Submitted via the Commission's observation portal

2 July 2026

Third Party Planning Observation in respect of An Coimisiún Pleanála RED III planning application - Case reference: PAX92.324279 - which pertains to proposed development comprising a 10 year planning permission for the proposed development of Ballincor Wind Farm and all associated infrastructure located within the townlands of located within the townlands of Cloonaheen, Ballincor Demesne, and Curralanty, County Offaly, and Clonfree, Castletown and Cronekill, County Tipperary.

Fig. 23: Shadow Flicker Minutes per Day – WTGs N163 (Source: EIAR Chapter 16, Figure 16-1)

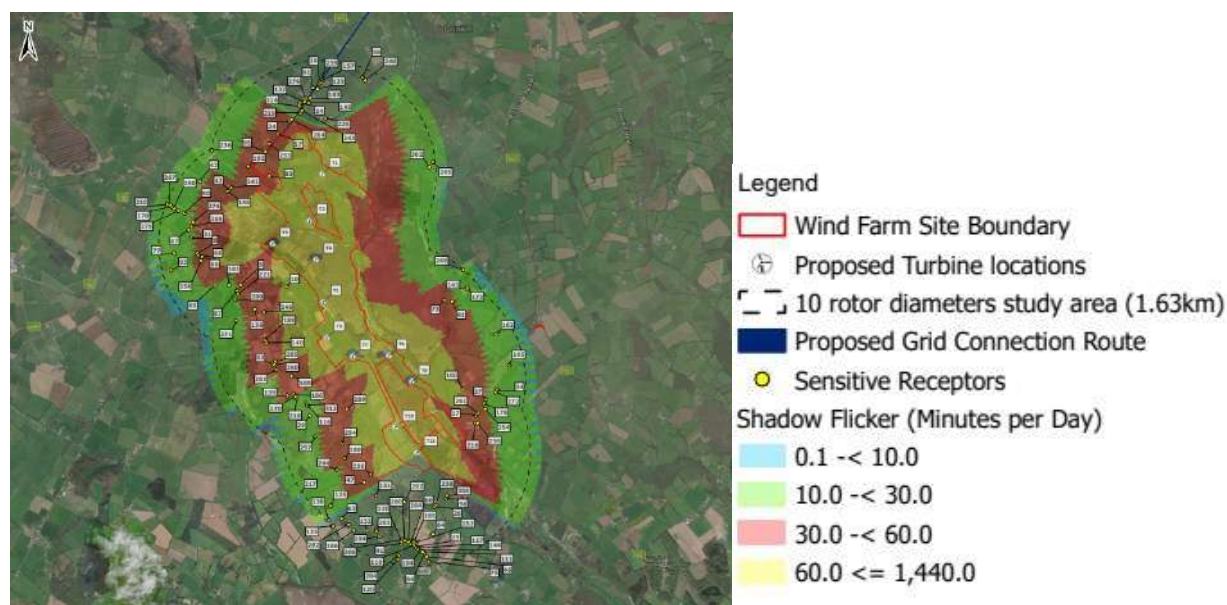
Figure 16-1, which at 6 pages long is too long to long to extract into this report, is particularly important in this regard, as it illustrates the spatial extent of predicted shadow flicker effects associated with Scenario 1, comprising the N163 turbine configuration. The EIAR confirms that Scenario 1 represents the maximum extent of the moving shadow and encompasses the full range of turbine dimensions proposed. This figure therefore provides a clear visual demonstration of the extent to which sensitive receptors are located within areas predicted to experience shadow flicker effects.

Figure 3.3 Flood Plain and proposed Infrastructure

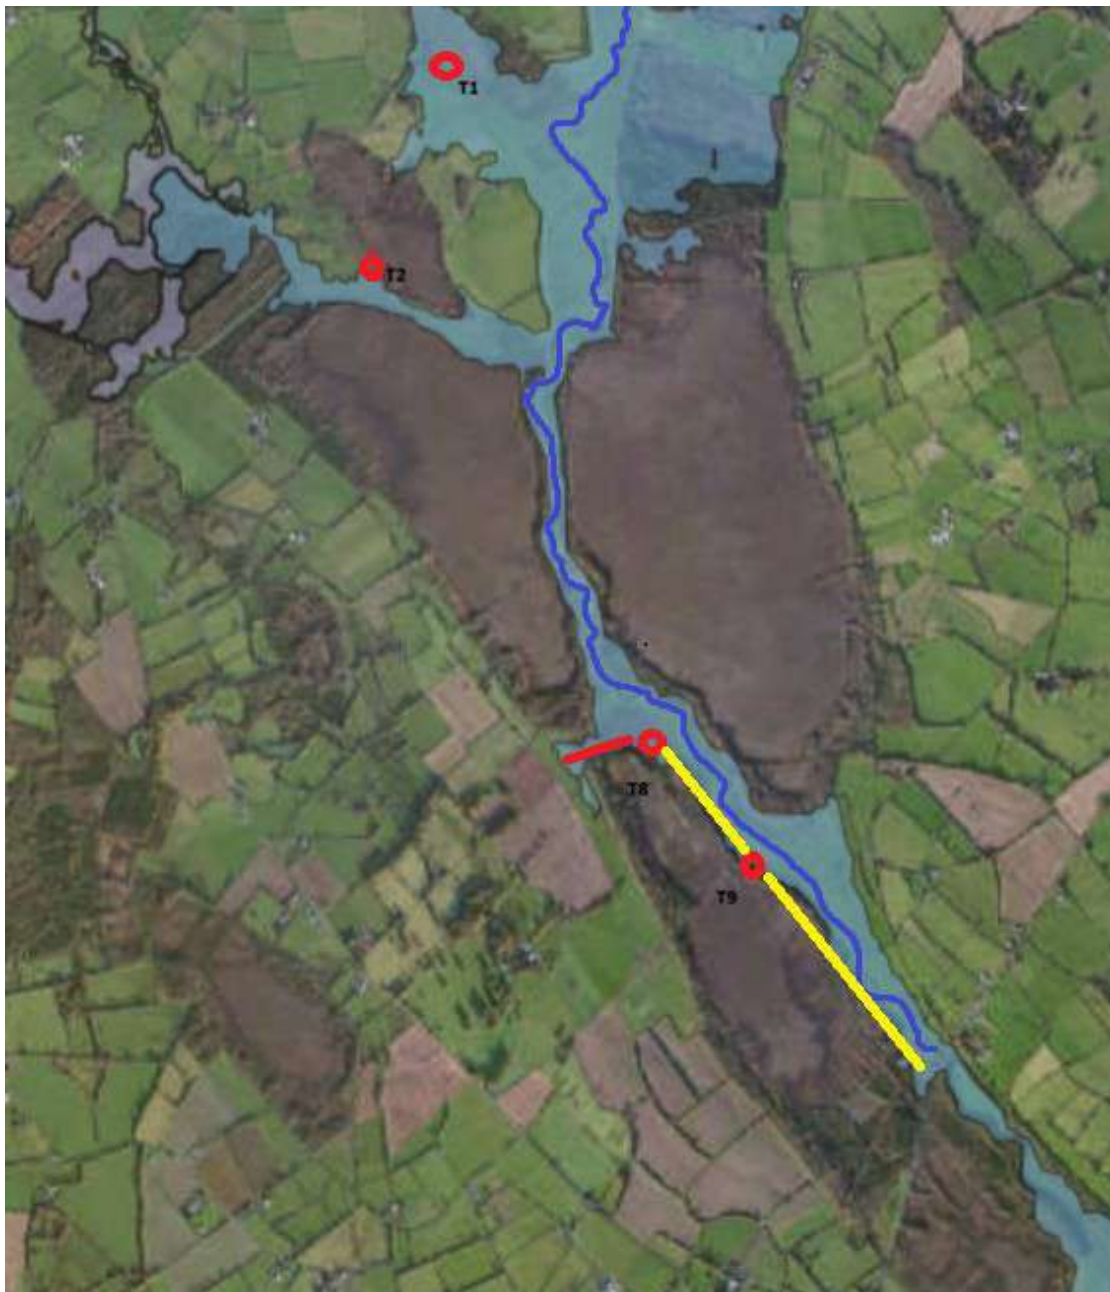
Figure 3.3 below shows the access tracks, and T1,T8, T9 in the flood plain and T2 in very close proximity in regular flooding activity

Figure 3.4 Sharavogue Bog – River is Boundary

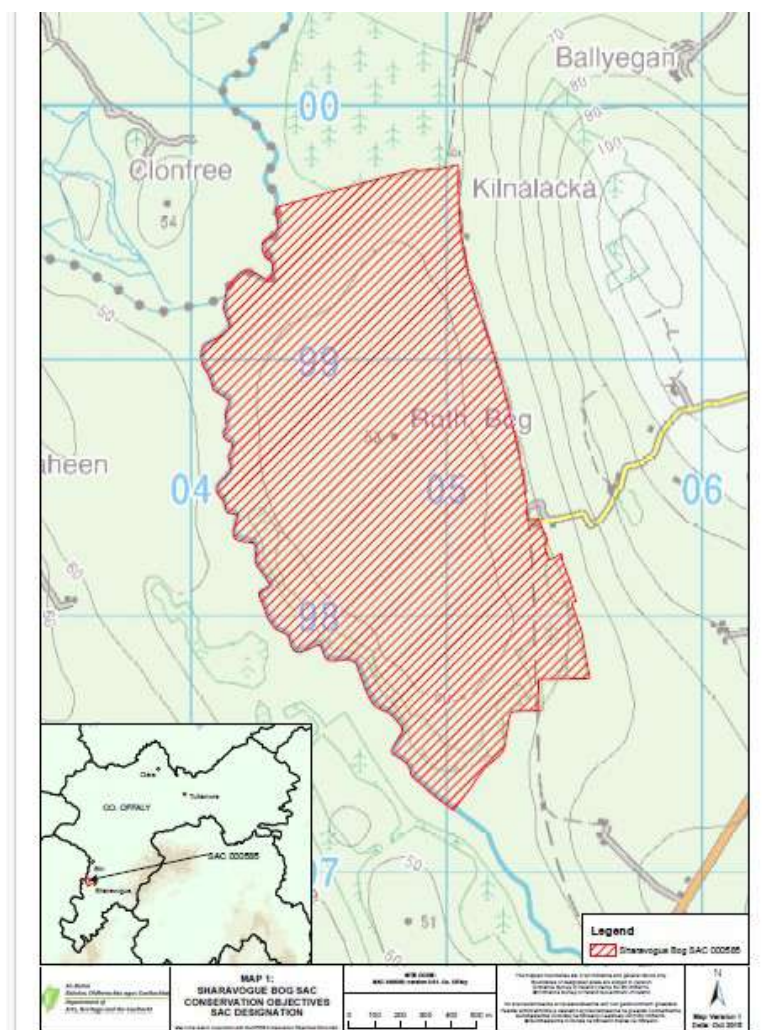
Figure 3.4 below shows the relationship between Sharavogue Bog SAC (site code 000585) and the River Brosna. Sharavogue Bog sits immediately east of the wind farm site, with its western boundary defined by the River Little Brosna — the same watercourse that forms the eastern boundary of the development. As previously shown the Proposed development site will use the river as its eastern boundary so a direct overlap is presented. The SAC boundary is classified in the Applicants documents as less than 10 metres from the wind farm perimeter at its closest point, adjacent to T8 and T9.

Figure 3-7: CFRAM MRFS Fluvial Flood Extents

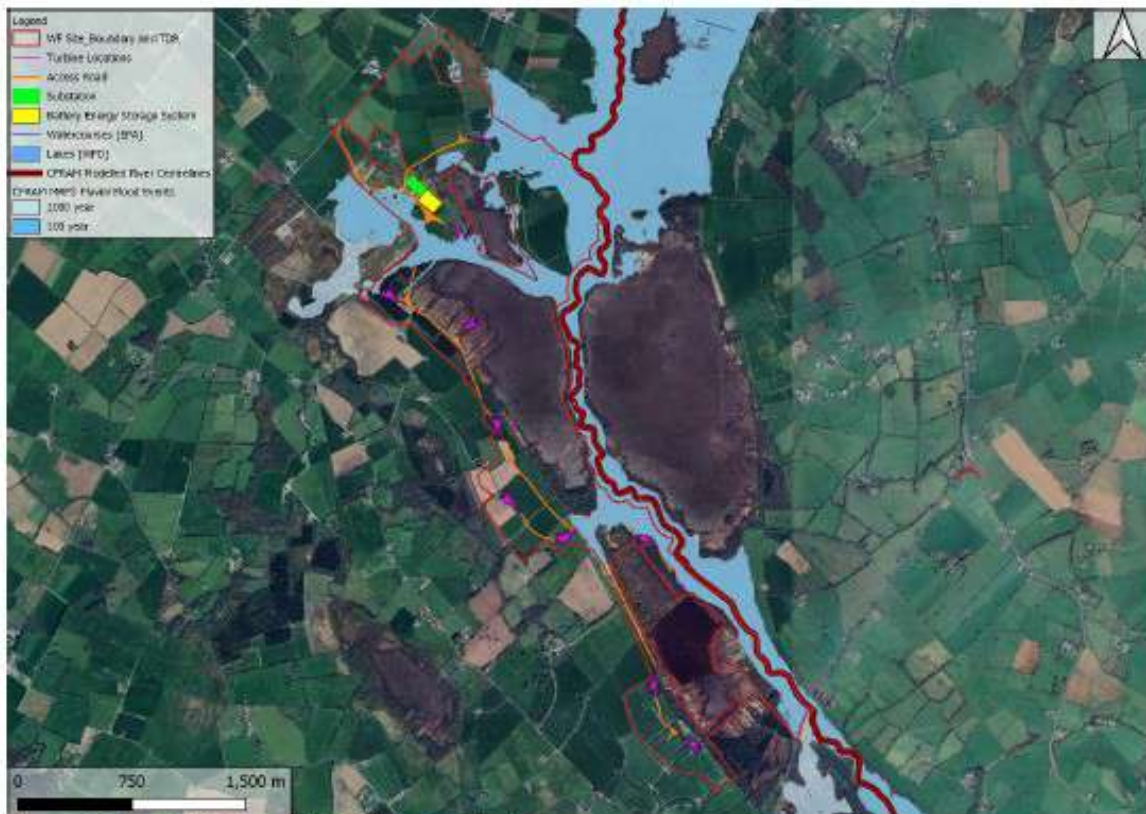
The MRFS applies a +20% uplift to peak flows to model the effect of climate change over the lifetime of the wind farm. The data shows that because the Little Brosna floodplain is flat, even a modest increase in peak flow translates to a significant expansion of the flood extent hence T9 jumping from 50% to 75% inundated at the same 1% AEP event. Further, note in an expanded Figure 3.6 below where and how the extended flooding travels. It moves closer to the SAC on the East side. Also note that the high end “+30% High end future scenario” although more likely in Flood Zone A is never engaged and in that scenario the water will travel closer again towards the SAC.

Figure 3.16: Trial Pits/Boreholes from RWE Application

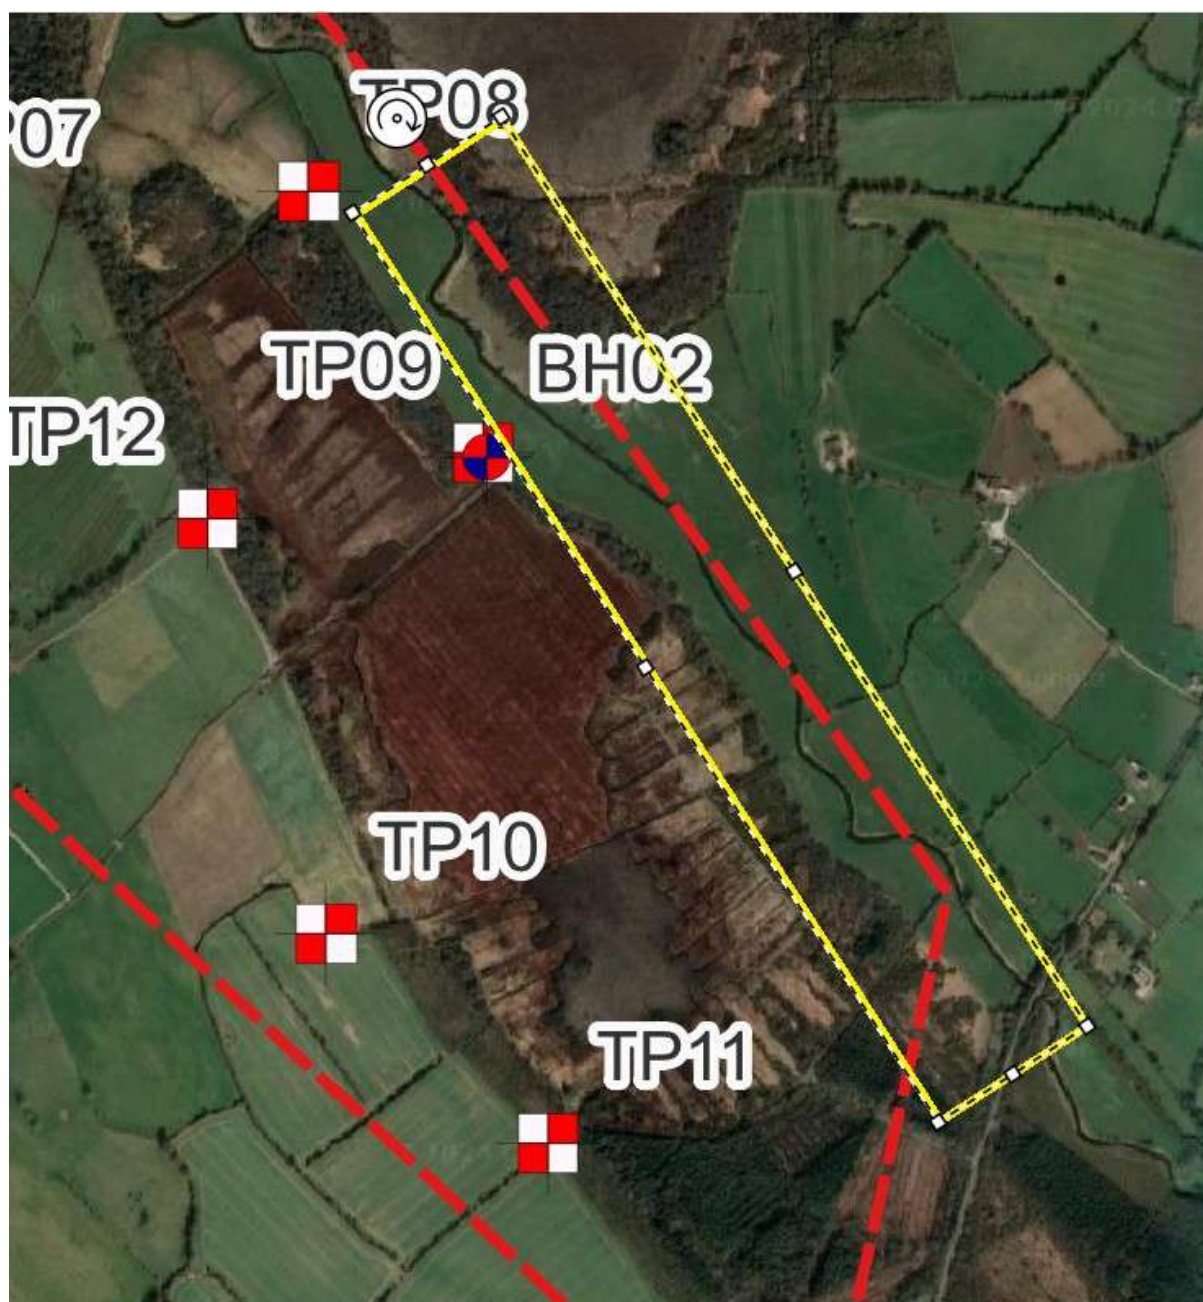
The ground investigation comprised 23 trial pits and 3 boreholes across the entire site. In the T8/T9 zone — the valley floor in Flood Zone A/B, closest to the river and the SAC — the investigation points are TP08, TP09 and BH02. All three are located at or near the turbine hardstand positions. See Figure 3.14 below. Not one trial pit or borehole was positioned along the access track alignment in this corridor. Peat probes in this area were located at turbine positions only. The claim that ground investigation has informed track design in this zone is not supported by the ground investigation data submitted.

This matters because the peat depth map (EIAR Figure 8-6, Appendix 8-2 PSRA page 40) shows the deepest peat on the site concentrated in precisely this corridor — 2.1–3.9m depths clustered around T4, T8 and T9 (EIAR Ch.8, p.8-22). The zone with the deepest peat, the highest flood risk and the greatest proximity to the river and SAC is the zone with the least investigation along the route where tracks will actually be built.

Figure 8-44: Cumulative theoretical visibility of the proposed Ballincor Wind Farm in combination with all other wind farms in the study area

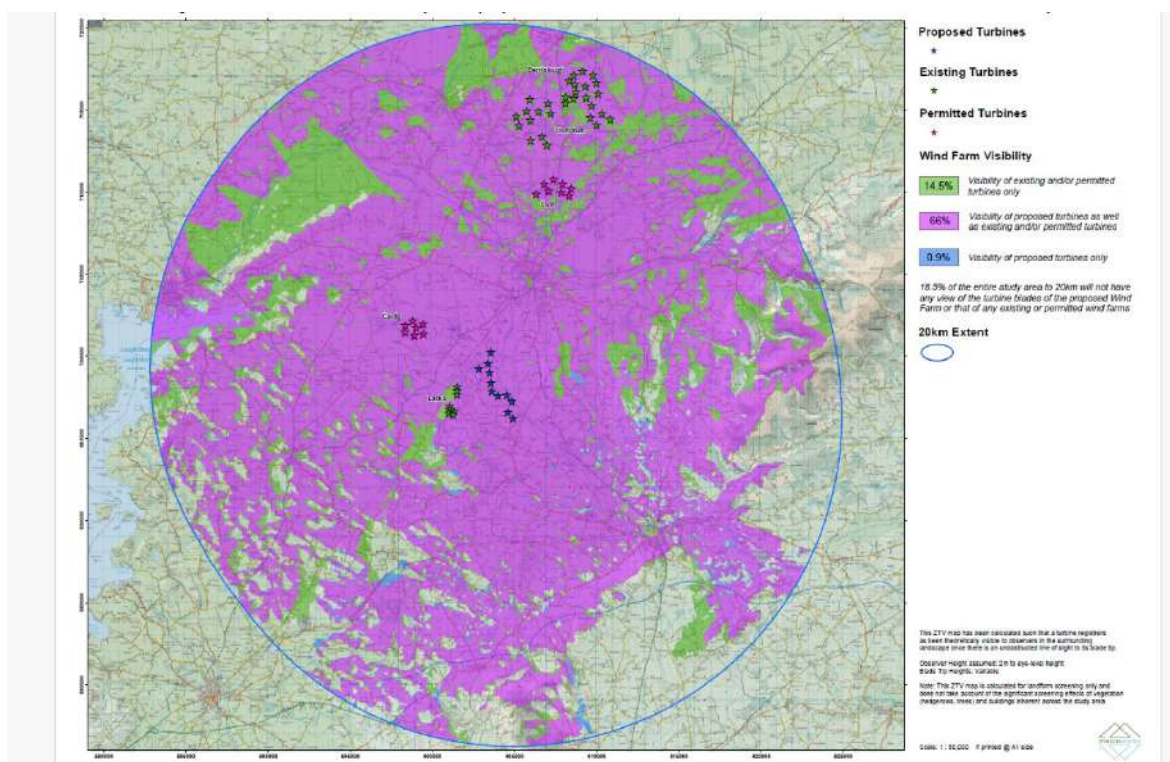
Section 12.7 of the chapter disposes of cumulative effects in summary terms. It acknowledges the operational Lacka Wind Farm, describes the proposed (Ballincor) and existing (Lacka, Carrig) developments together as "modest scale developments" that "do not contribute to a marked change in landscape character," and concludes that the area "will not become a landscape that is defined by wind energy development." It produces a cumulative ZTV (Figure 12.12) see below, notes that it shows near-universal overlap of visibility between the proposed and existing developments and then discounts its own map as one that "considerably overrepresents actual cumulative effects."
